Access Compliance Report Public Rights-of-Way (Curb Ramps)

Intersection ID: 53134Main Street:GARDEN_VIEW_DRCross Street:WADE_ARDREY_RDLocation:SWADA ID: AB06060B06B1Ramp Type:PerpDiagInitial Pass/Fail:FailOverall Compliance:NoSeverity Score:8.75

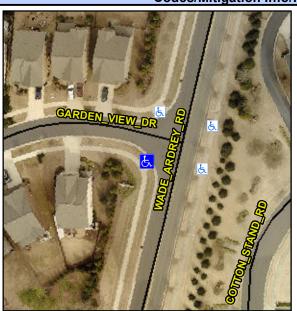
Not Found, R304.5.1

Remove & Replace Curb Ramp With Two New Directional Ramps or Equivalent.
